SUPPLEMENTAL INSTRUCTION

PROJ.: **Boys and Girls Club Prince of Wales**
PROJ. No.: **1716**
DATE: **August 16, 2018**
S.I. No. **S.I. - 037**

Revision to mechanical ceiling layouts at new washrooms, changerooms

Mechanical Contemplated Change Notice (MCCN)

MSK-5

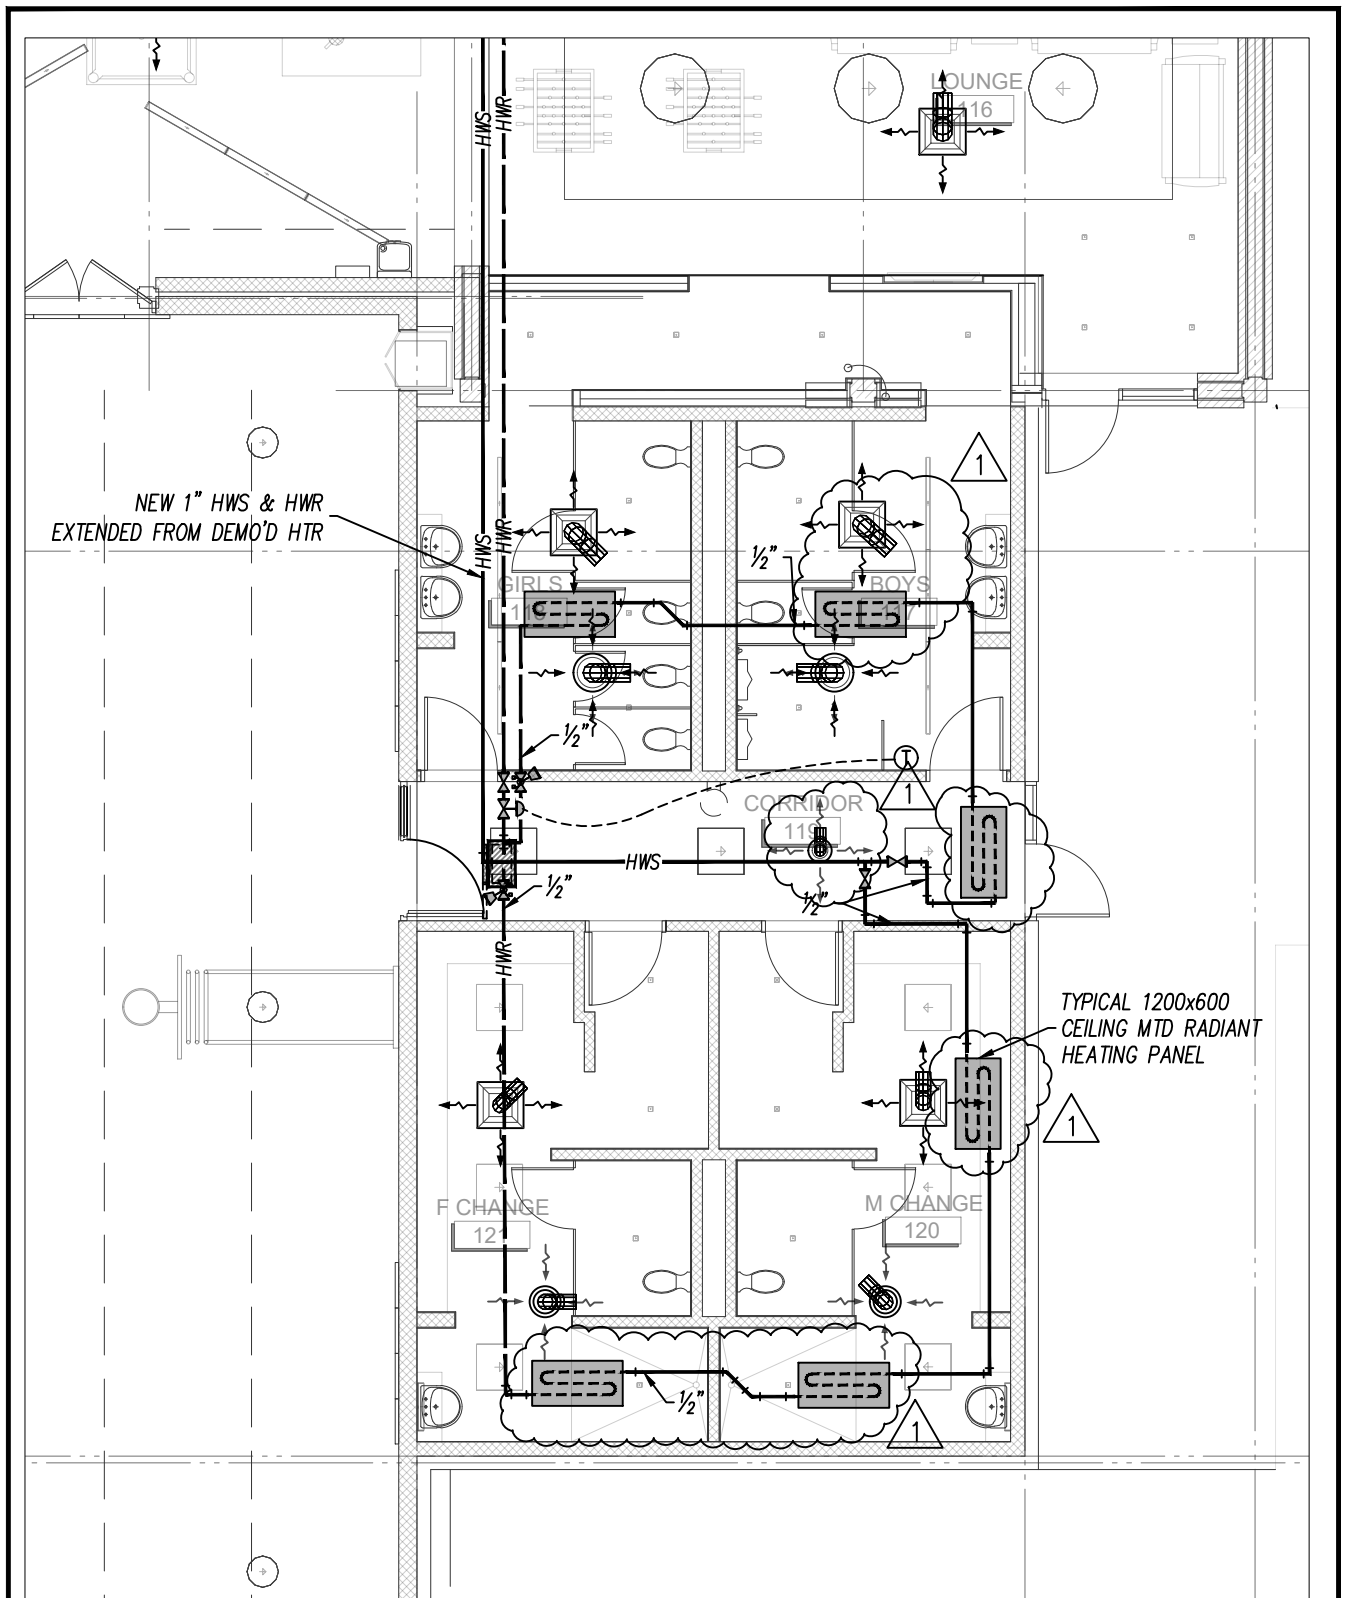
1. See MSK-5
 - a. Revised location of Radiant Ceiling Panel heaters to remove conflicts with light fixtures and diffusers in various rooms: corridor, m change room, m change room shower, f change room shower.
 - b. Revised diffuser location in boys washroom to remove conflict with lighting
 - c. Revised hall way diffuser location to center between lights
2. No adjustment in contract price expected.
